ENGINEER'S SUPPLEMENTAL INSTRUCTIONS NO. TWELVE (12)
(Via Posting to FTP Site and Electronic Mail)

RE: Harold D. Thompson Regional Water Reclamation Facility (HDTRWRF)-Phase 1
ENGINEER'S SUPPLEMENTAL INSTRUCTIONS NO. TWELVE (ESI-012)

The ESI-012 addresses modifications to the project drawings relative to the Pumping and Disinfection Building which were issued September 16, 2011 for preparation of the CMO covering the foundation scope of work. The modifications described in this ESI appear on the Pikes Peak Regional Building Department (PPRBD) foundation only permit submittal drawings. Please distribute this ESI to any and all suppliers and subcontractors so the items described herein may be accounted for in the foundation CMO prepared for the Pumping and Disinfection Building. The following is a list of drawing modifications arranged by sheet number.

1 PUMPING AND DISINFECTION BUILDING ELECTRICAL GROUNDING PLAN
EPD-3 SCALE: SCALE: 1/4" = 1'-0"

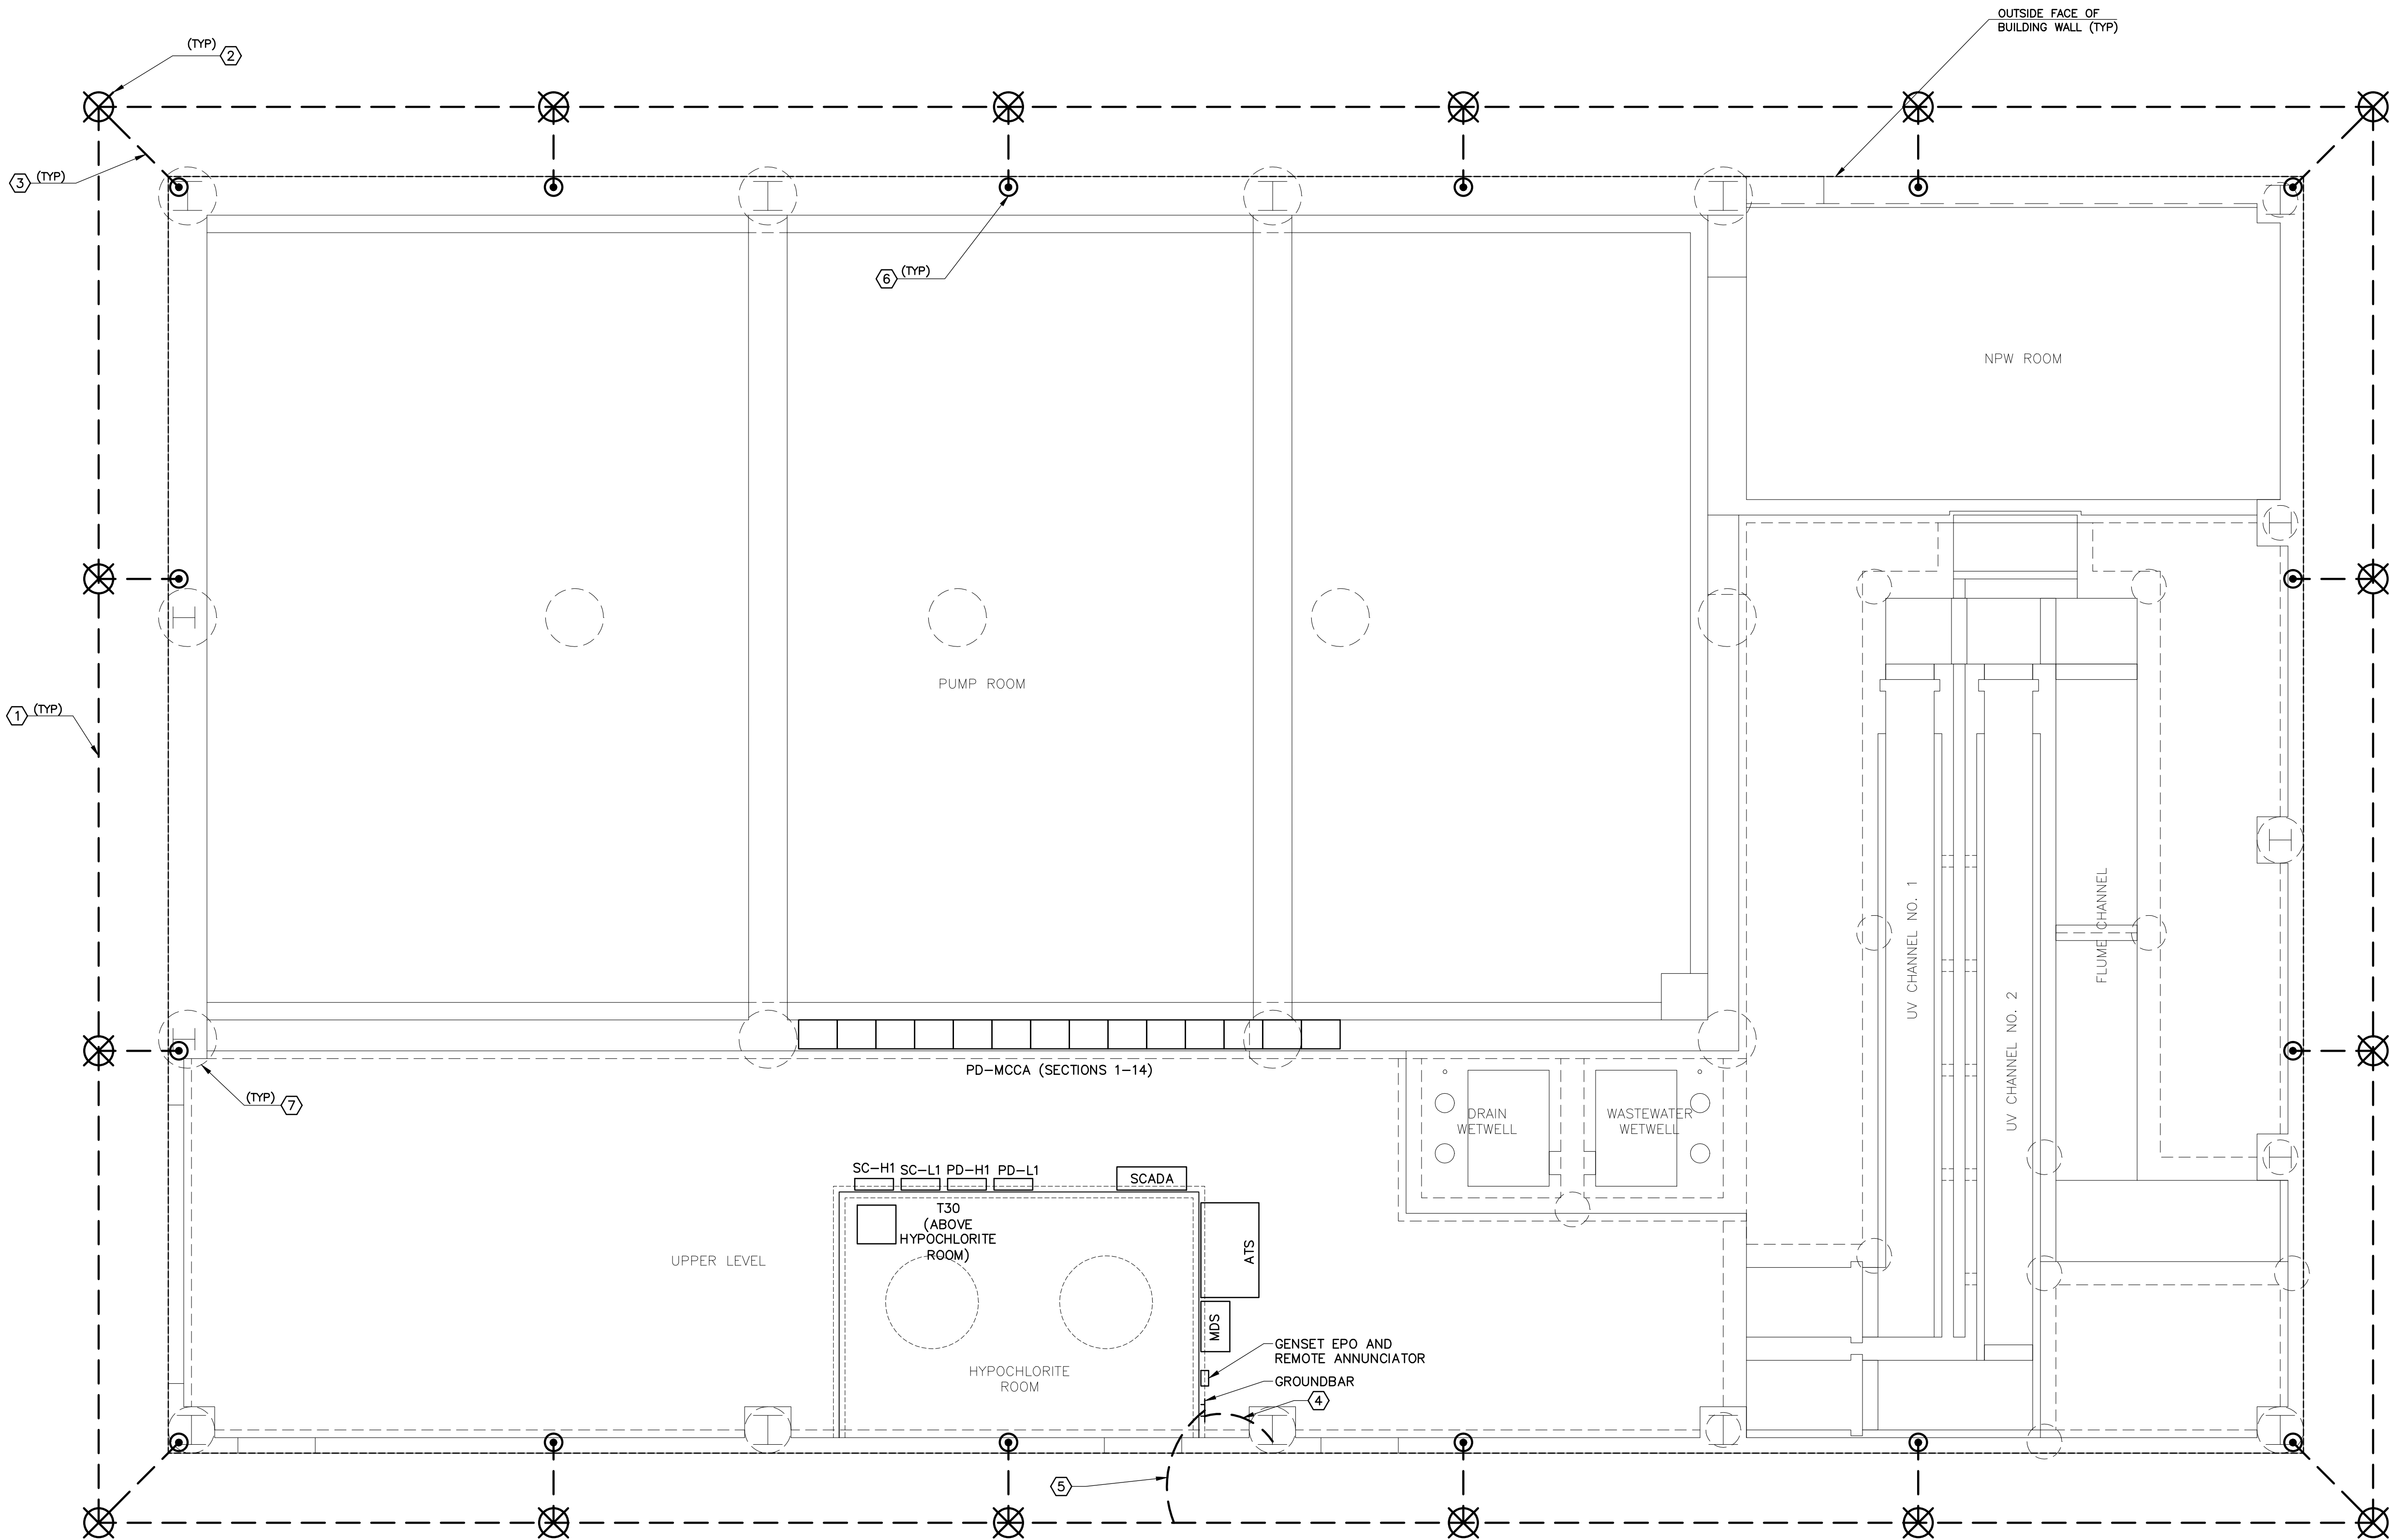
- Sheet EPD-3
 - Revised Keyed Note No. 4 to clarify the ufer grounding requirements
- Sheet EPD-4
 - Added a note referencing the Electrical Grounding Plan to clarify the ufer grounding requirements
